COMMENTS
of the
CALIFORNIA UNIONS FOR RELIABLE ENERGY
on

Preliminary Staff Assessment
Beacon Solar Energy Project
Application for Certification (08-AFC-2)

April 30, 2009

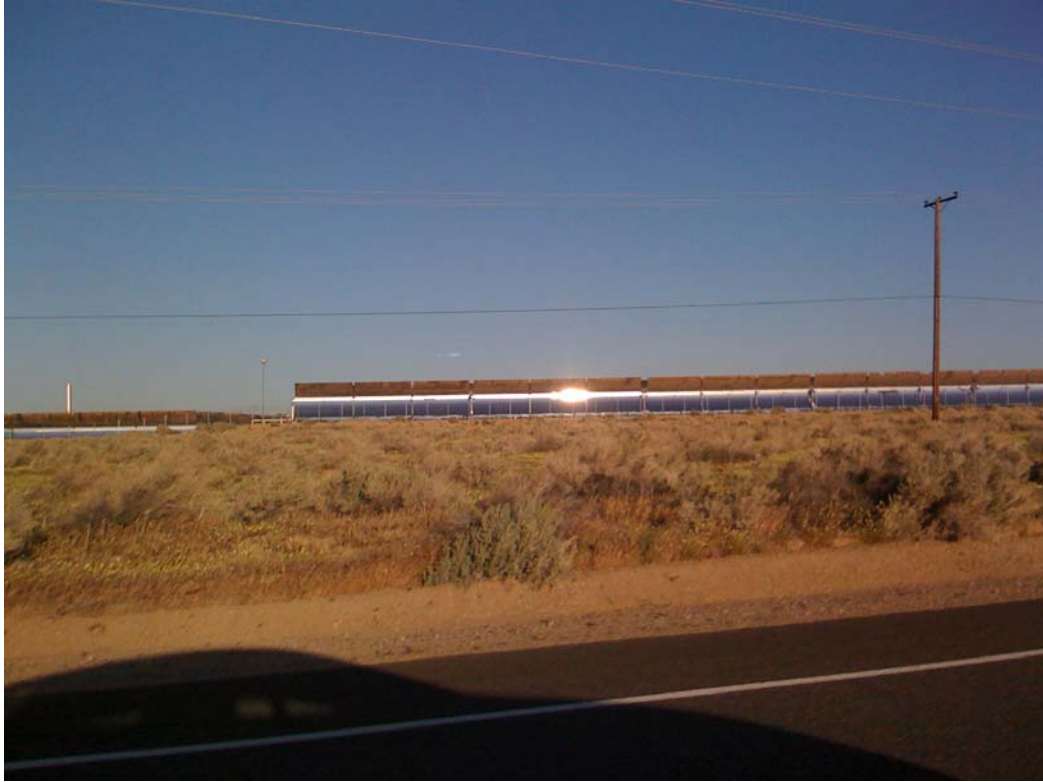
The PSA concludes that “the project would generate a less than significant new source of light or glare to nighttime or daytime views with the effective implementation of the conditions of certification.”²⁹⁷ However, a glint and glare study was not prepared for the Project.

The photographs below were taken of the Kramer Junction SEGS facility on April 25, 2009 at 7 a.m. The Kramer Junction facility employs the same technology proposed by the Project. The photographs show a significant glare that may pose a risk to motorists passing the Project on State Route 14.

A glint and glare study should be prepared for the Project that takes into account the potential for horizontally reflected light from the parabolic mirrors and the reflector tubes that may pose an attractive nuisance or an annoyance to motorists while gazing at the completed Project. The glint and glare study should consider seasonal changes in incident sun angle and in reflected light and should attempt to quantify the intensity of the reflected light. The results of the glint and glare study should be included in a revised PSA for public review and comment.
